**ADDENDA
00 91 13 A-03**

HHAngus HHAngus & Associates Limited Consulting Engineers 1127 Leslie Street, Toronto, ON, M3C 2J6 Canada www.hhangus.com T 416 443 8200 F 416 443 8290	PROJECT: FORT ST. JOHN HOSPITAL CT SCANNER REPLACEMENT	SCALE:	DATE:	PROJECT No:	REVIEWED BY:	DRAWING No:	REV:
		1:200	2020-05-26	2191374	W.E.	SK-E1	00

4 LEVEL 0 PART PLAN - MAIN EQUIPMENT FEEDER ROUTING

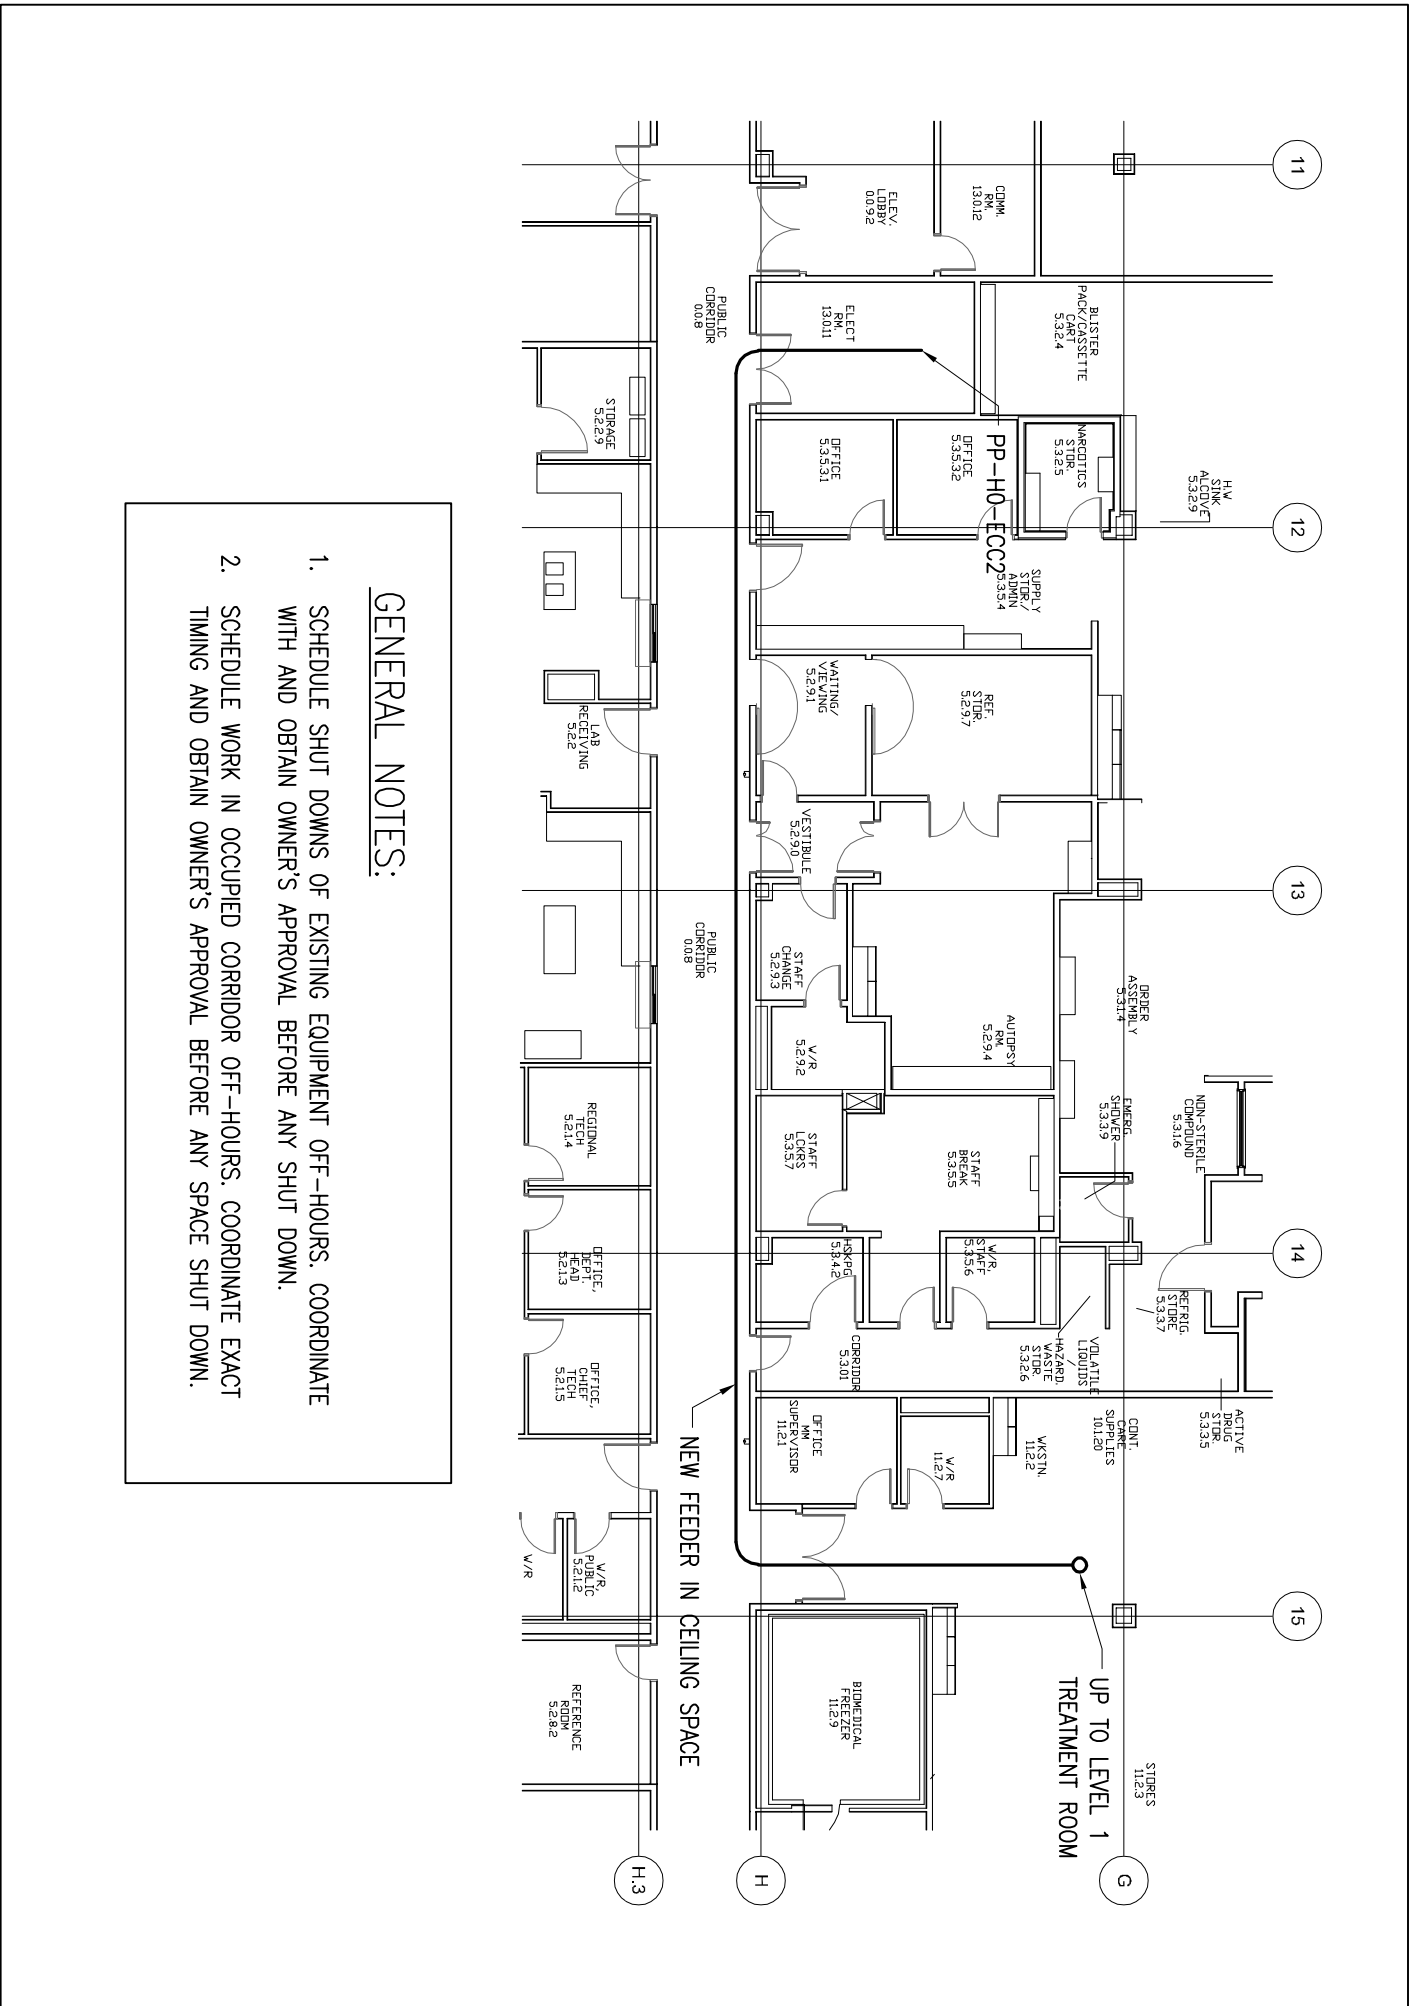
1.1 Reference Drawing E5 – Electrical Supplemental Floor Plans and Details and attached sketch SK-E1

.1 Add sketch SK-E1 to drawing E5 as new detail #4.

2.2 Question: A feeder is required from P0-H0-ECC2 to the new CT Scanner, please clarify which path we are to use to route this feeder as the shorter most direct path to run this feeder would have to go through the operating pharmacy.

Response: See '1 Electrical Drawings' above.
